Re: Turkey Point Units 3 and 4  
Docket Nos. 50-250 and 50-251  
Response to NRC Request for Additional Information Regarding  
Extended Power Uprate License Amendment Request No. 205 and  
Reactor Systems Issues

RESPONSE TO NRC RAI REGARDING EPU LAR NO. 205  
AND SRXB REACTOR SYSTEMS ISSUES

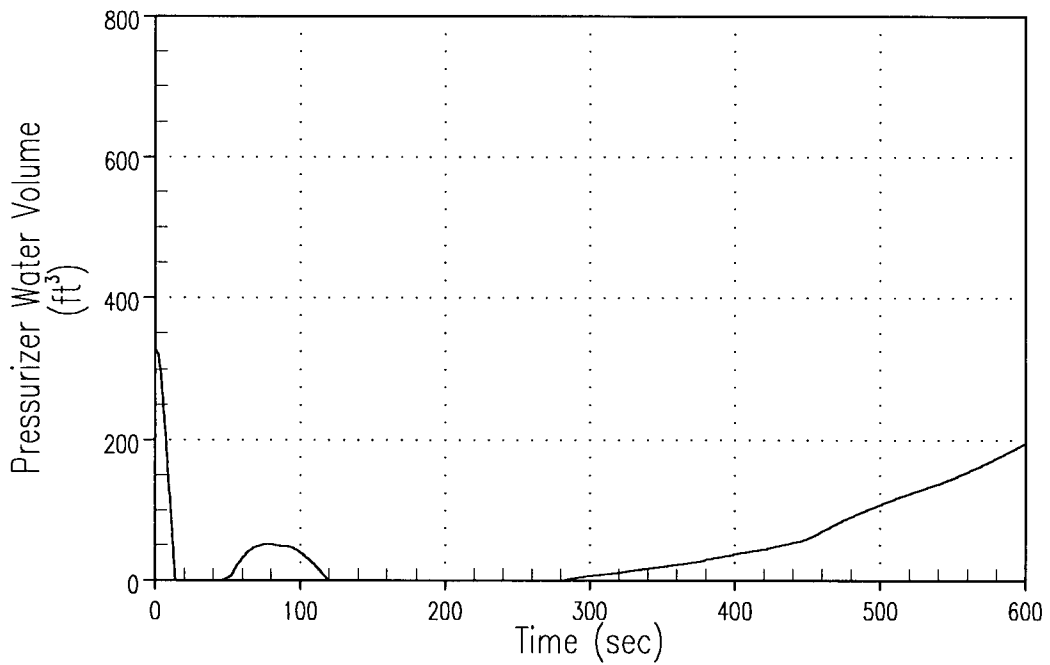
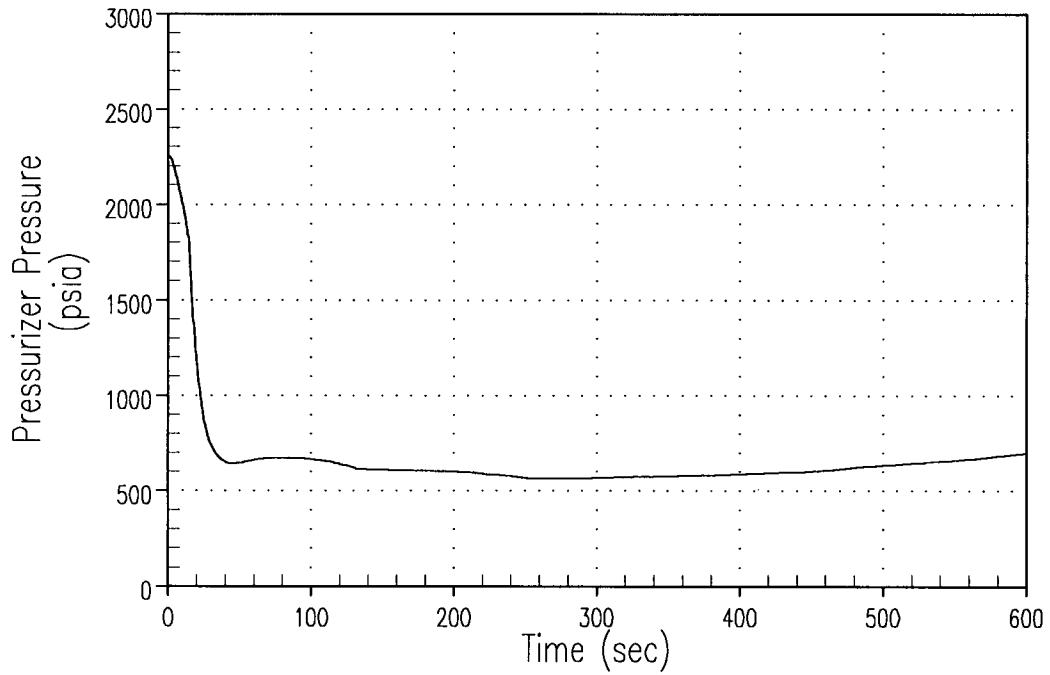
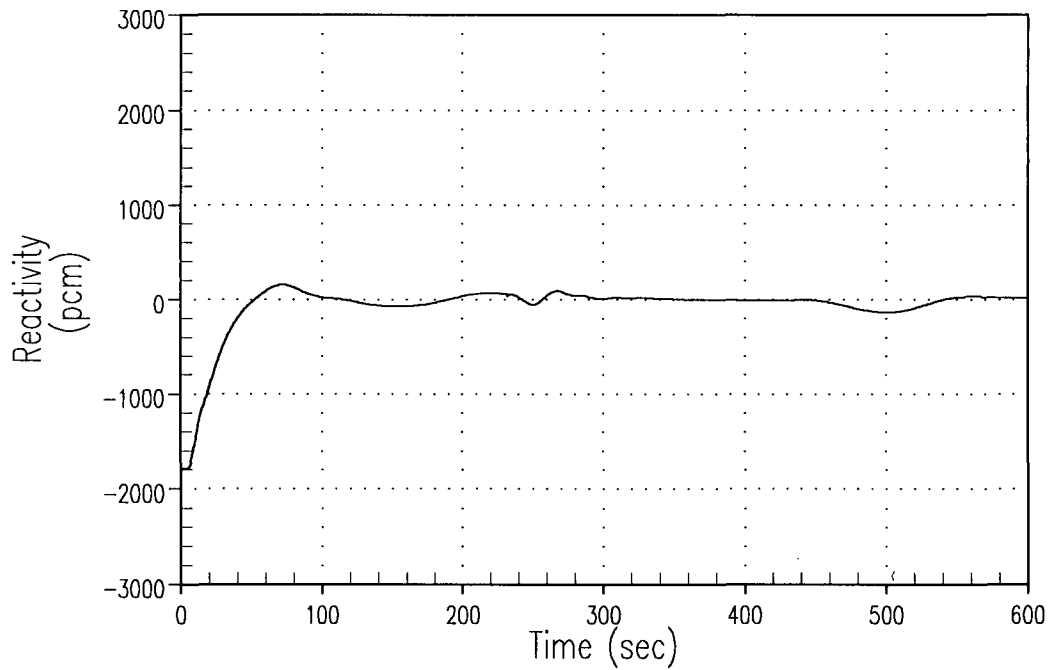
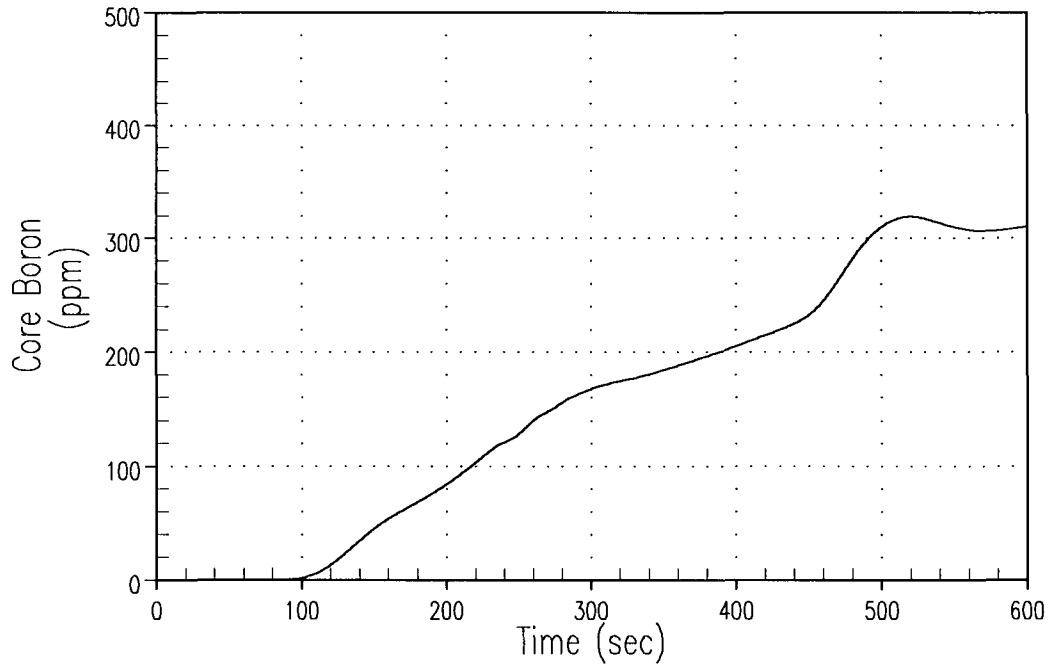
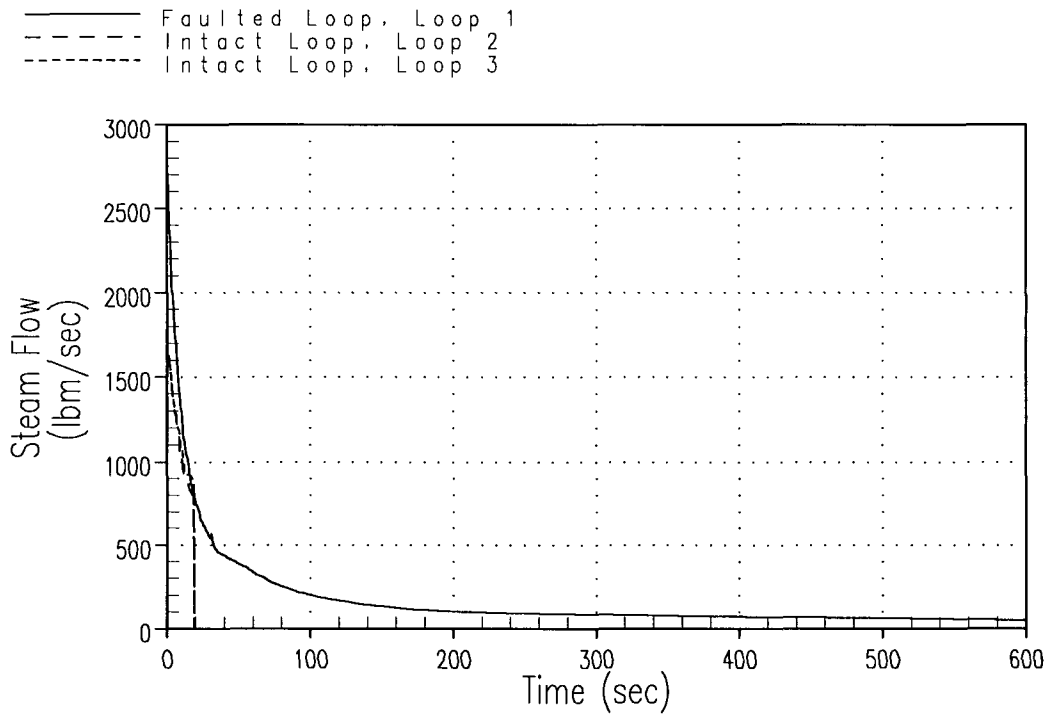
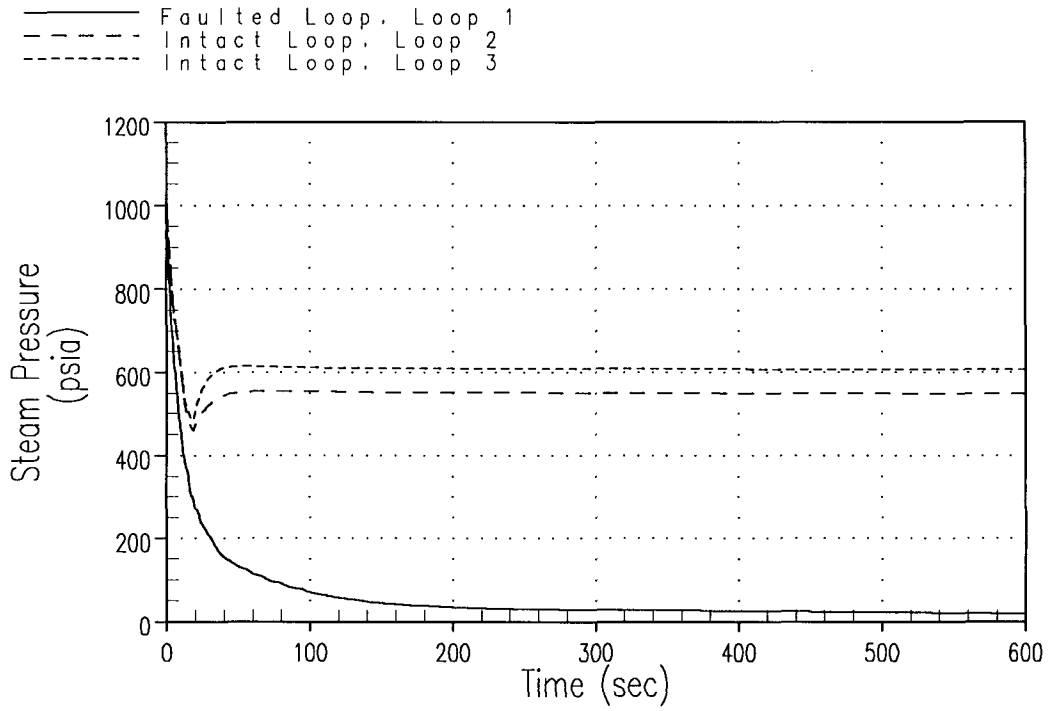
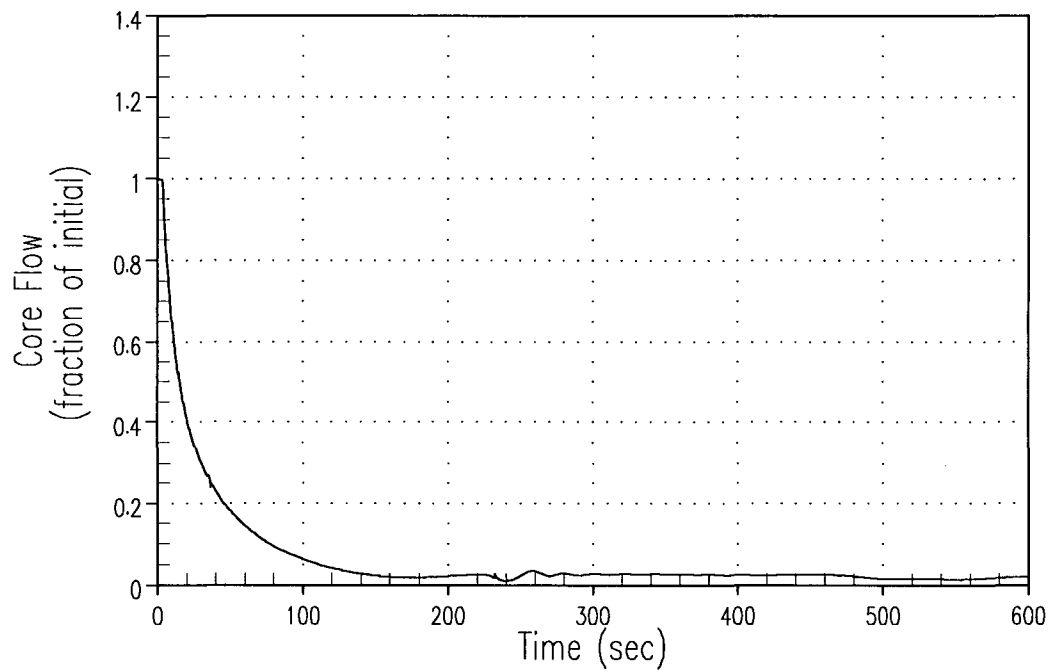
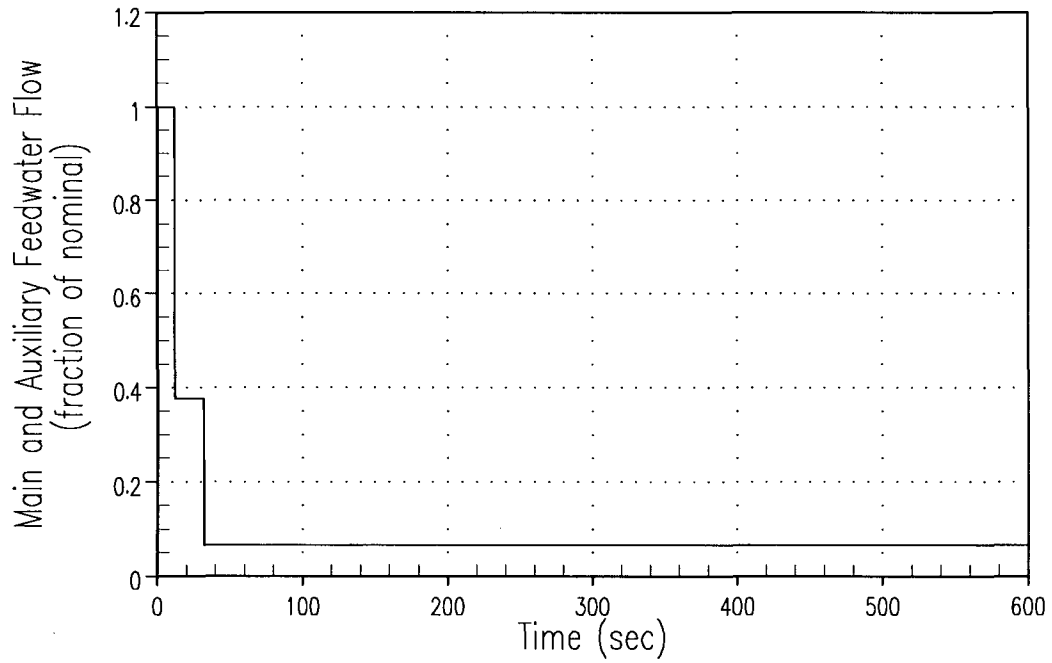
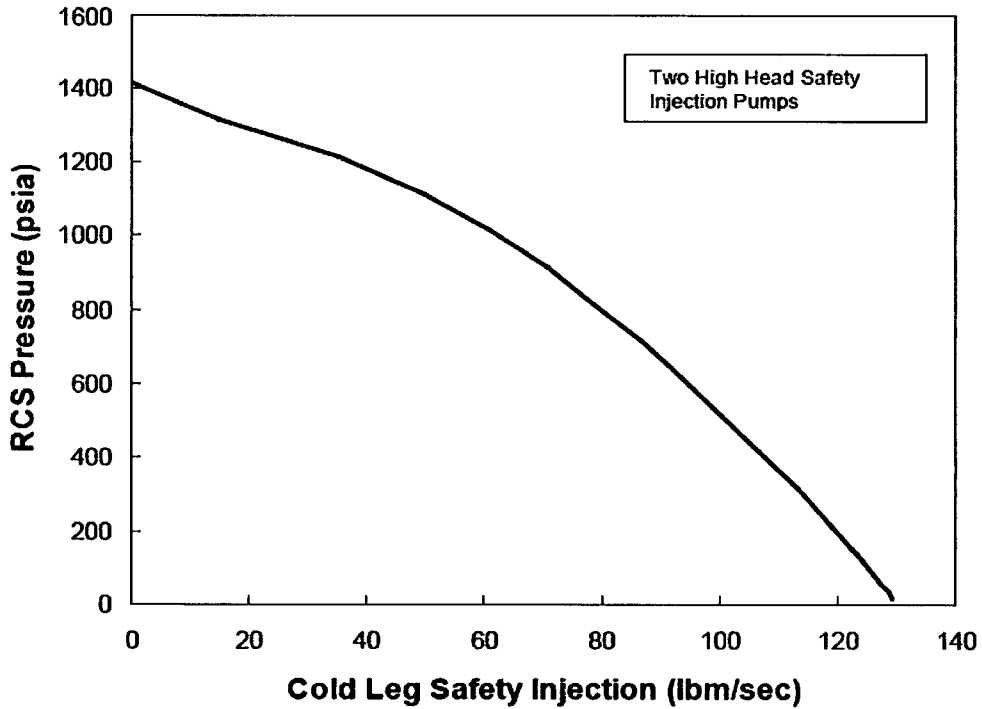
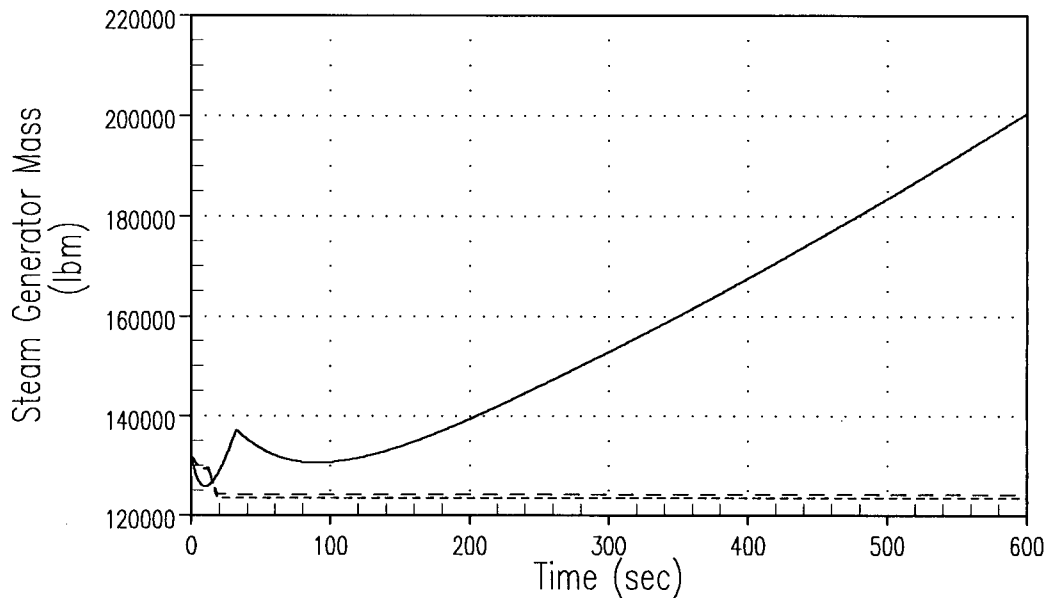
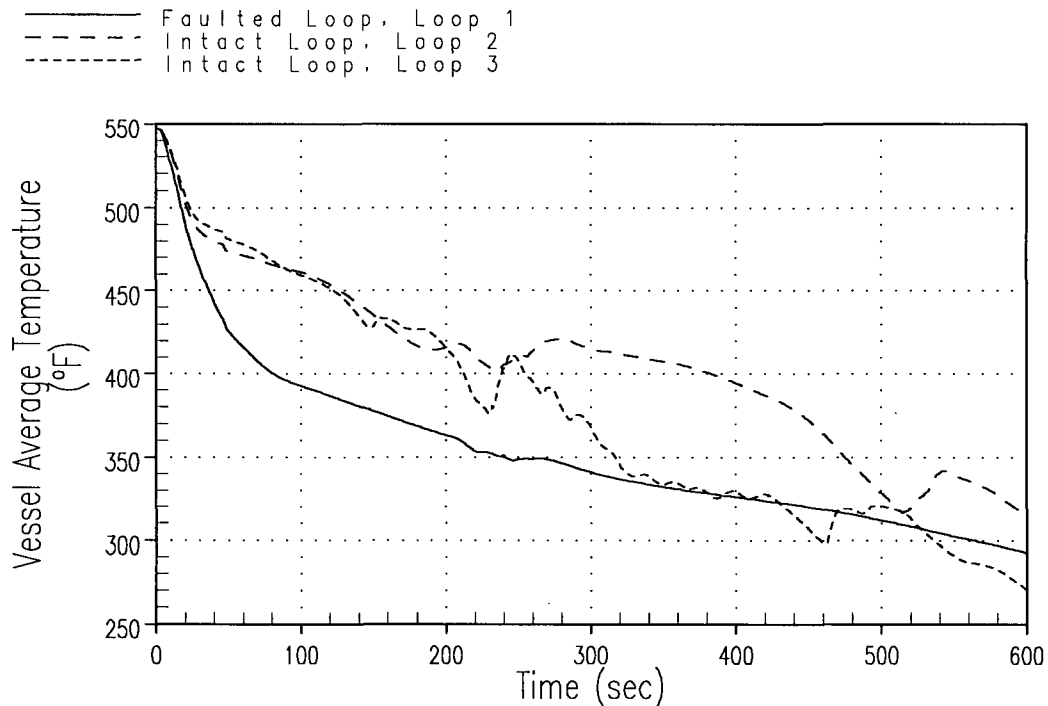
- a. LR §2.8.5.1.2.2.1.2 states that, "Cases were analyzed both with offsite power available (full coolant flow is maintained) and with a coincident loss of offsite power (causing the reactor coolant pumps to coast down 3.0 seconds following the break)." Provide the results of the analysis of the major rupture of a steam pipe at HZP, without offsite power, to show that the above design criterion is satisfied. Include a sequence of events table indicating the times and values of peak heat flux and minimum DNBR, and transient plots that are comparable to the reported results of the equivalent steamline break case with offsite power. Include a transient plot of core flow.**

The sequence of events for the analysis of a major rupture of a steam pipe from HZP conditions, without offsite power, is provided in Table SRXB-1.3.7.a; the transient plots for this case are provided in Figures SRXB-1.3.7.a-1 through SRXB-1.3.7.a-8. The value for the peak core heat flux in this case is 0.0334 (fraction of nominal); given the non-limiting nature of the overall plant response for this case in comparison to the case in which offsite power is available (reactor coolant pumps continue to operate), no detailed calculation of the minimum DNBR was performed for the case without offsite power. The analysis demonstrates that the results of the case with a coincident loss of offsite power are bounded by the more limiting

results associated with the case where offsite power available; therefore, all applicable safety criteria are satisfied for this event.

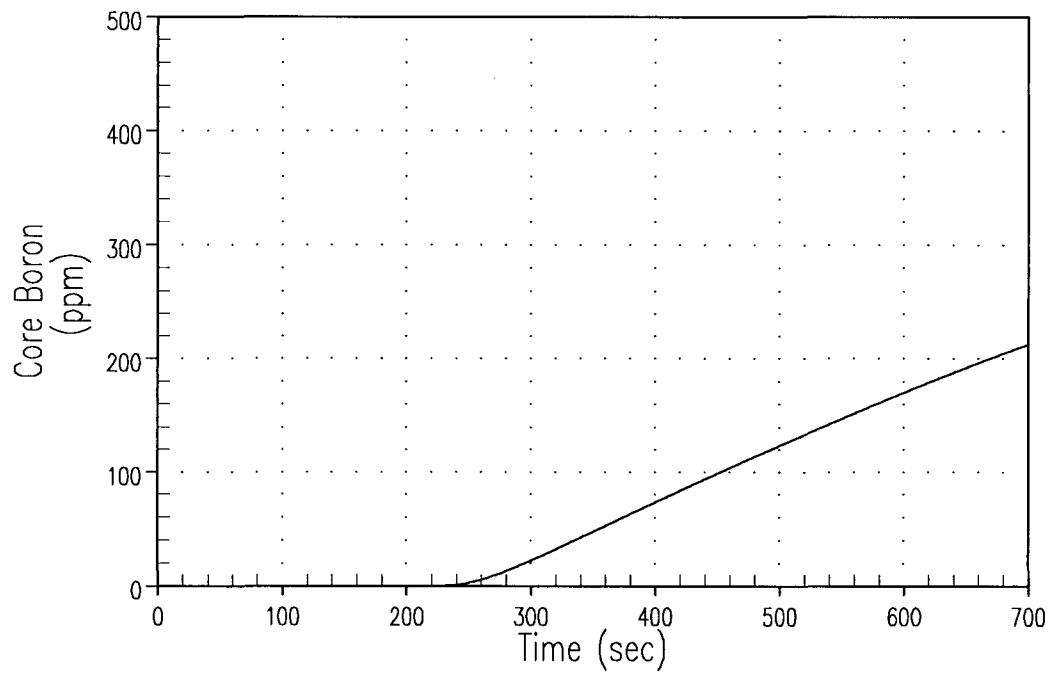
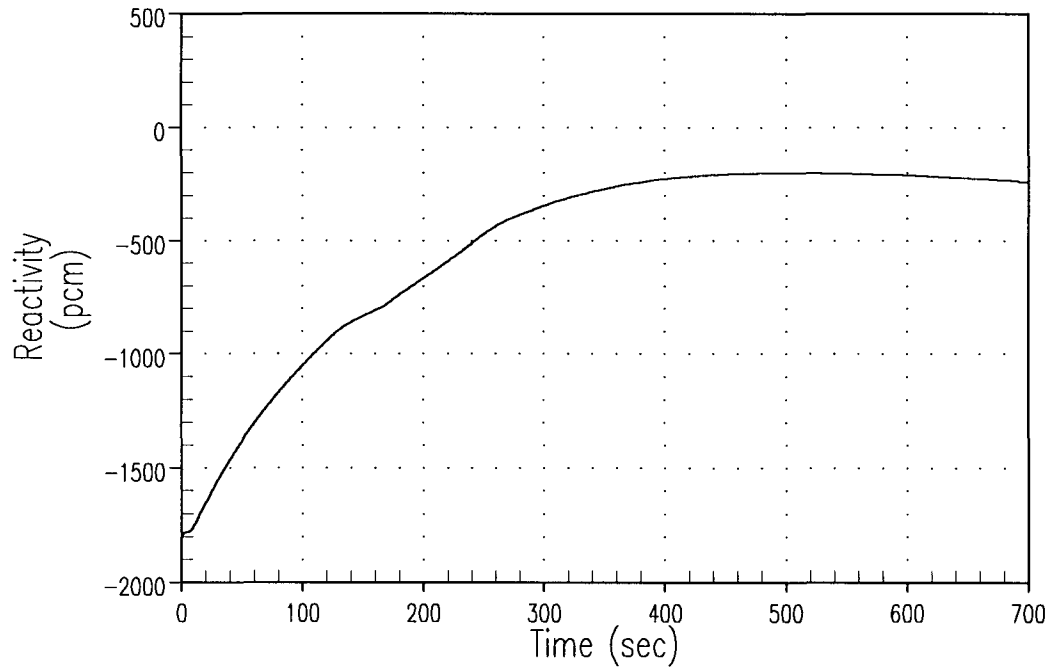
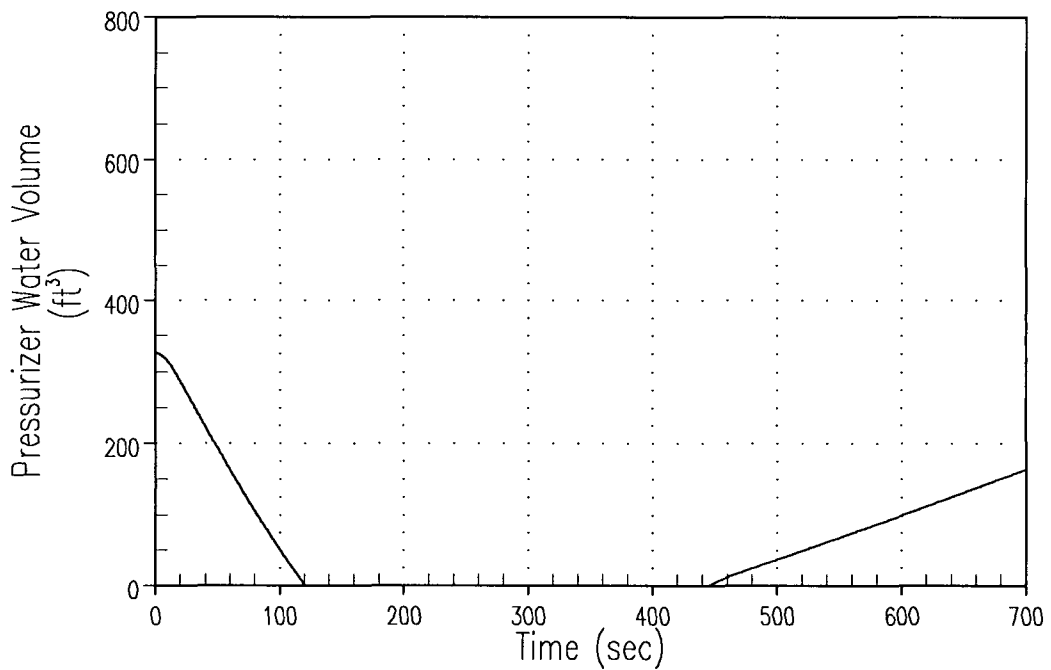
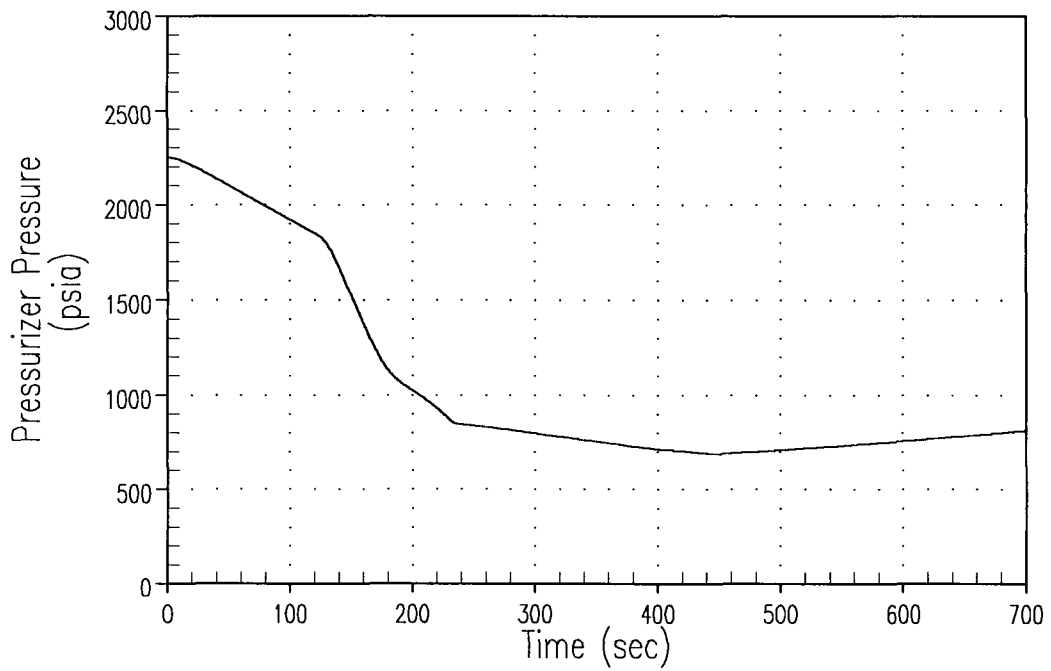
- b. Provide the analysis results of a credible steam line break, including a time sequence of events table listing values for peak heat flux and minimum DNBR (if applicable) as well as their times of occurrence. (If question 1 (above) is answered, then this question is withdrawn.)**

For the analysis of a main steamline depressurization (i.e., credible steamline break) at Hot Zero Power conditions, steam flow was assumed to initially increase to approximately 8% of the total full power steam flow (approximately 255 lbm/sec at 1000 psia), which bounds the flow increase resulting from the inadvertent opening of any single steam system valve (steam dump, steam relief or steam safety valve). The sequence of events resulting from this analysis is provided in Table SRXB-1.3.8.b; the transient plots for this analysis are provided in Figures SRXB-1.3.8.b-1 through SRXB-1.3.8.b-3. As shown in Figure SRXB-1.3.8.b-2, there was no return to criticality predicted for this event. Therefore, no detailed calculation of the minimum DNBR was performed for the main steamline depressurization analysis.
